Pre-application briefing to Committee

Reference No: PRE/2016/0419

Address: 'Kwik Fit' site, 163 Tottenham Lane, Crouch End, N8 9BT

Proposal: The pre-application proposal is for redevelopment of the site to provide 26 residential units together with 1,258sqm of commercial floor space within 2 ground floor premises and plant and store room within basement (use classes A1, A2, B1, B2 restricted to MOT testing, mechanical servicing and repairs of motor vehicles and D1)

Proposed front elevation (to Tottenham Lane)

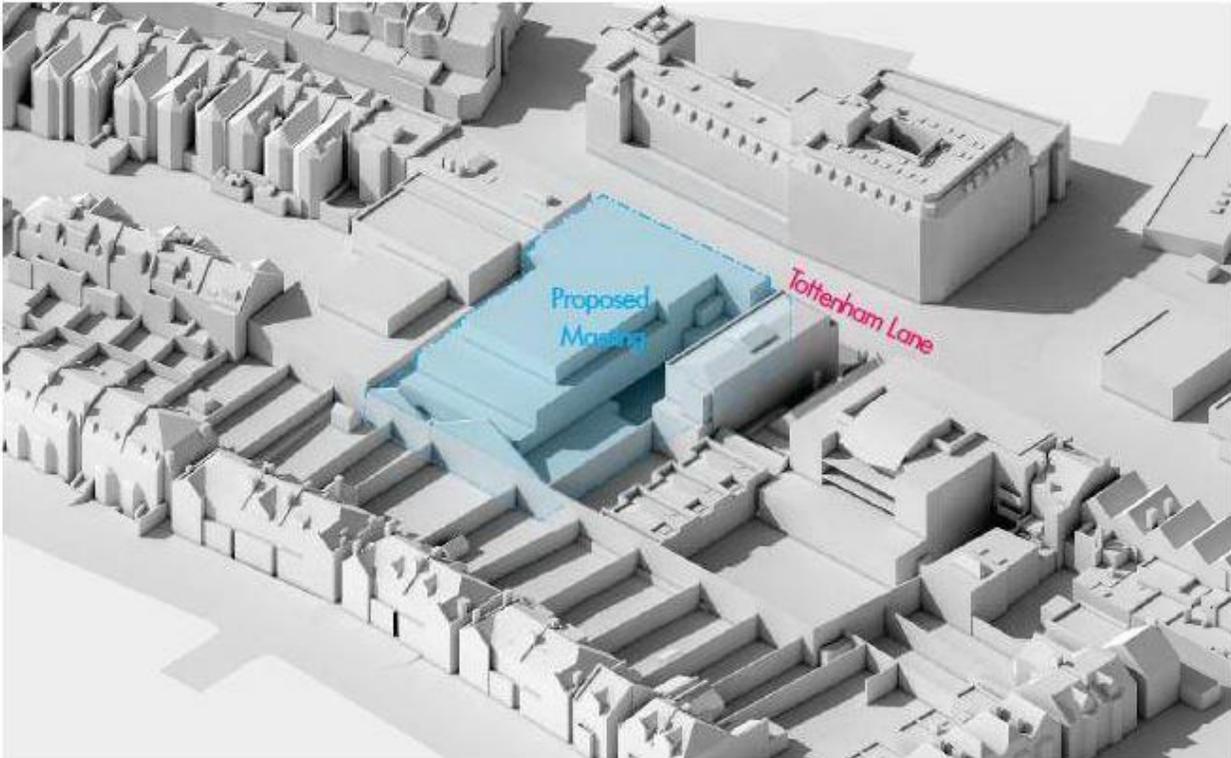
- 7.4 Since the original proposal, the design approach has been amended and the overall bulk and scale of the proposal has been significantly reduced, which is welcomed. However, concern remains over the design of the front elevation, particularly that the proportions have gone from too horizontal to too vertical. It is also noted that the design is yet to have a follow-up review from the Quality Review Panel (scheduled for 22 February 2017). It is therefore considered that the design requires some refining prior to submission of any forthcoming planning application.
